# 1968 Corvette: Service Bulletin: General Information

**Bulletin No:** 68-T-43

**Date:** April 24, 1968

Subject: 1968 CORVETTE  
GENERAL INFORMATION

Astro Ventilation - Poor Air Flow

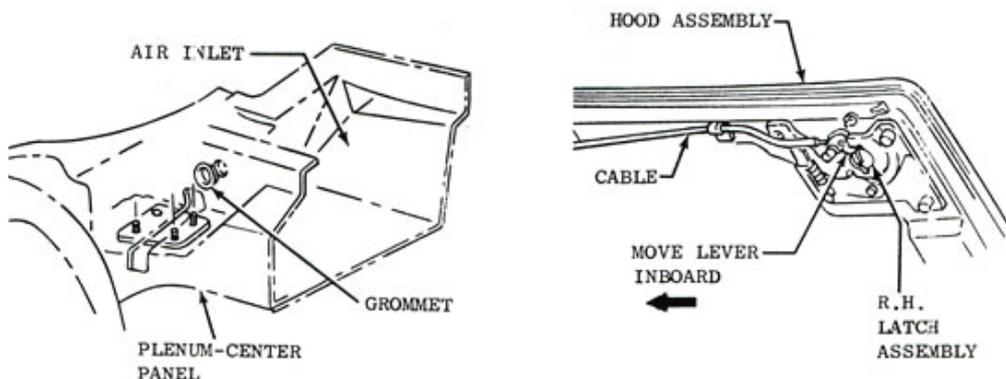
The amount of air flow through the Astro Ventilation System may be restricted if the flapper type valves are improperly cemented to the valve frame. These valves are located under the rear deck and should swing freely as pressure builds up in the passenger compartment.

In instances where the valve action is restricted, separate the rubber flaps from the frame along the bottom and sides. The Astro Vent ducting and cowl kick pad vents should also be checked for leakage as this will reduce air flow at the nozzles.

Rear Bow Lock Remote Control Cable Rattle

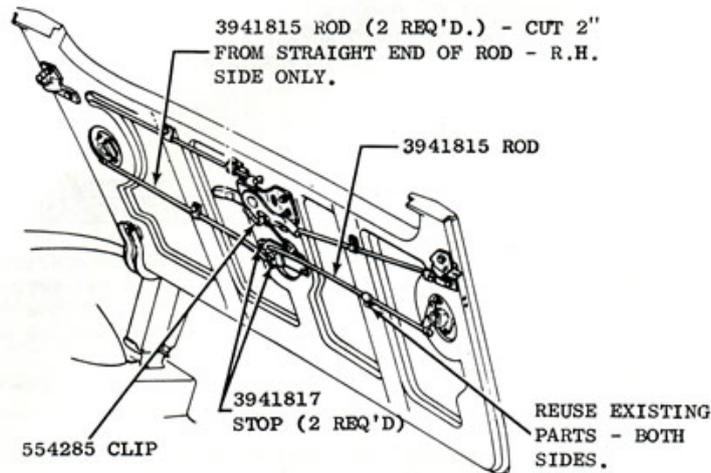
Remote control cables used on early 1968 Corvette Convertible models could rattle against the rear compartment lid. Production replaced these cables with rods on 1/2/68.

Complaint vehicles may be updated by installing the rear bow lock remote control rods as indicated on the sketch below.

Headlamp Door - Inoperative

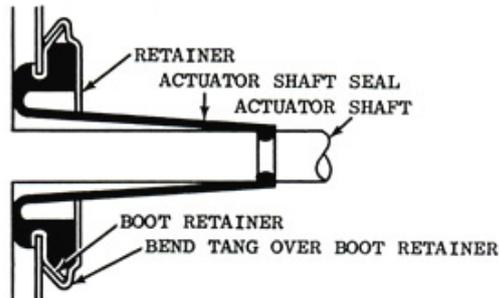
Headlamp doors which become inoperative due to sticking actuator shaft seals, should be corrected by replacing the inner shaft seal. This seal, in some cases, will stick to the actuator shaft causing the seal to pull out of the actuator. The headlamps may be operated manually as outlined in the 1968 Corvette Owners Manual when this occurs. The new style actuator seals went into production effective with Serial No. S410514. The actuator seals may be replaced as follows:

1. Remove actuator assembly per Section 12, Chassis Service Manual
  2. Remove the outer boot from the actuator
  3. Remove the inner seal and wipe the seal flange and actuator shaft dry

4. Installation and lubrication of actuator shaft seal
    - a) Install seal using protective cover over shaft threads (protection is needed to avoid cutting of internal seal bead by threads)

- b) Make certain seal grommet is properly seated in the actuator cover and interior bead at small diameter of seal fits in the groove on the shaft (See sketch)

- c) Apply a liberal film of silicone lubricant over entire exterior surface of actuator shaft seal, excluding grommet
  5. Install the retainer by bending the three (3) tabs over edge of boot retainer. (See sketch)

- IMPORTANT:** Do not distort boot retainer when bending over the tabs. If distorted, leakage can occur
6. Install the outer boot and reinstall the actuator assembly as described in Section 12 of the Chassis Service Manual
